# UNITED STATES PATENT AND TRADEMARK OFFICE

APPLICATION NO.	FILING DATE	FIRST NAMED INVENTOR	ATTORNEY DOCKET NO.	CONFIRMATION NO.
10/696,932	10/30/2003	James F. McGuckin JR.	1255	1044

<b>Office Action Summary</b>	<b>Application No.</b> 10/696,932	<b>Applicant(s)</b> MCGUCKIN ET AL.	
	<b>Examiner</b> Richard Shaffer	<b>Art Unit</b> 3775

### DETAILED ACTION

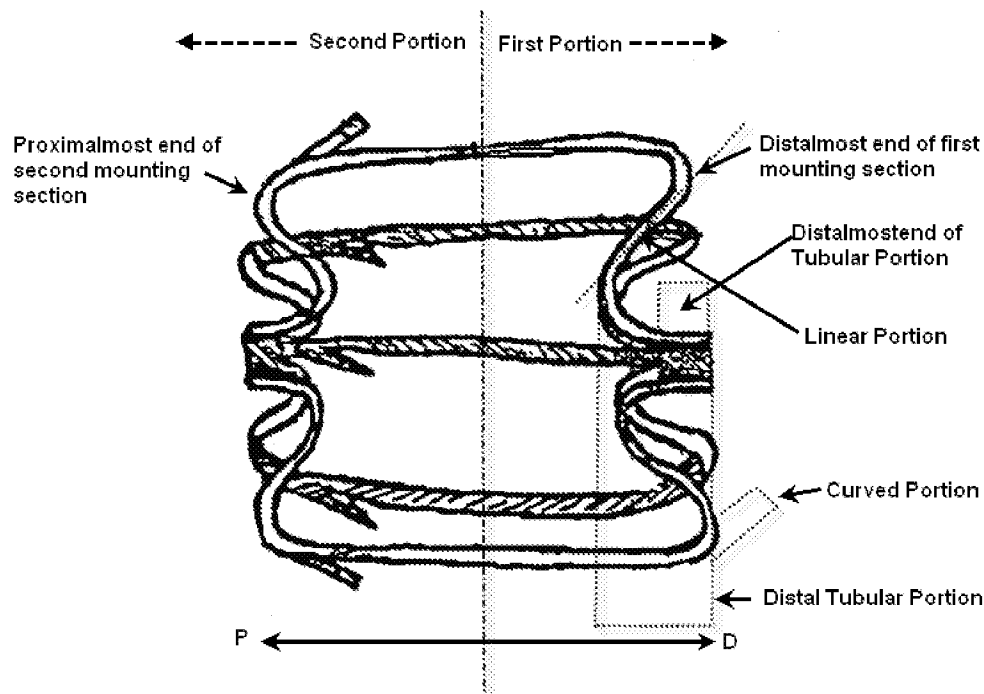
al teach (**Figure 35; Column 18, Lines 34-55**) that an expandable device for placement against a bodily tubular structure with an S-shape end portion provides an elongated mounting section which improves contact area. It would have been obvious to one having ordinary skill in the art at the time of invention to design the filter of Bosma et al according to the structure taught in Van der Burg et al in order to improve fixation within the blood vessel. In regard to applicant's extensive claim language defining the relationship between the filter section and mounting section, see the Figure below depicting how the structure of Van der Burg et al meets the claimed limitations.

Applicant states that Van der Burg et al lack a distalmost end point of a distal tubular portion proximal of distalmost end points of struts of the mounting section. As shown in the figure in the previous page, at least the two bottom struts on the right are shown distal of the distalmost point of the tubular section as well as the two back struts on the left side being proximal of the proximalmost point of the tubular section.

Applicant additionally contends that Van der Burg et al lack linear portions of the mounting sections extending axially and radially inward. Again, as previously shown, there are portions that depict a linear strut member.

Applicant also states that Van der Burg et al lack the proximalmost and distalmost end points of the tubular portions axially aligned with a region of the linear portion. As already described in this remarks, there are portions further from the center of the device including a portion of the linear portion therefore axially aligning the distalmost/proximal most tubular end points with the linear portions of the struts.
